**Field Change Order Number: 00-AS800 F001**  
**Field Change Order Name: ASR800 Combo Slot –12v issue**  
**Customer Document Number: EK-COR64-CL**

## Field Change Order Instructions

Subject: AlphaServer 800 64-bit PCI slot restrictions

Figure 1

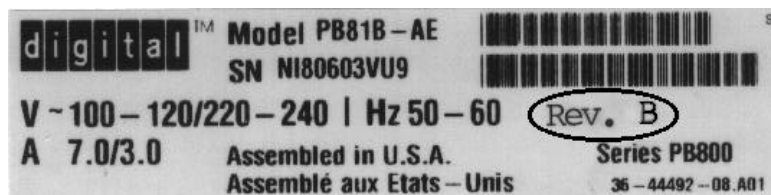
Digital has redesigned the system module to correct the problem and our manufacturing plants are now shipping only AlphaServer 800 systems that have this design change implemented. You can quickly determine if your system is affected by reading the revision of the system on the model number label on the back of the system enclosure. The systems that have had this problem corrected are marked with a Revision B or later. An example of the Revision B system label is shown in Figure 1 (see oval; the location of the revision text may vary). Any system that does not have a revision letter on the label is considered a Revision A and is affected by this problem.

**Figure 2**

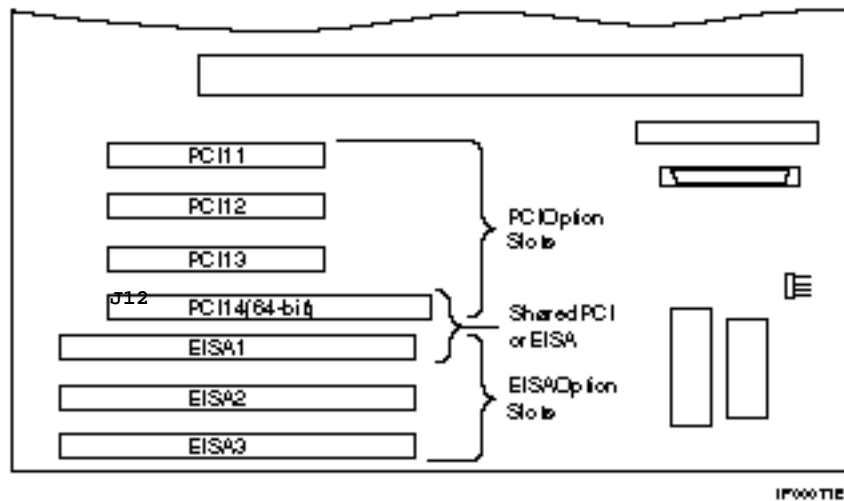
Digital has determined that a condition exists in the AlphaServer 800 system module which affects the 64-bit PCI option slot #14 (J12) that may cause electrical damage to some 32-bit and 64-bit PCI option modules, or other devices that are installed into that slot. The 64-bit PCI connector pin that should be providing the option module with -12 volts is actually supplying +12 volts. Only options that require -12 volts are susceptible to damage in this slot and most options do not use this connector pin. To date, Digital has not received any reports of such damage. This condition does not pose a product safety hazard, and all other PCI and EISA option slots in the AlphaServer 800 are unaffected.

We suggest that as a precautionary measure, customers apply a piece of non-conductive tape across the top of the 64-bit PCI slot to inhibit installation of option modules. The affected 64-bit PCI slot can be identified by the legend “J12” marked adjacent to the 64-bit PCI connector on either variation of the system module. See Figure 2 below.

The FCO should be administered per the customers request, or at the next scheduled service call. Replace system board, 54-24803-01 with revision L04 or higher or replace 54-24803-02 with revision C01 or higher.
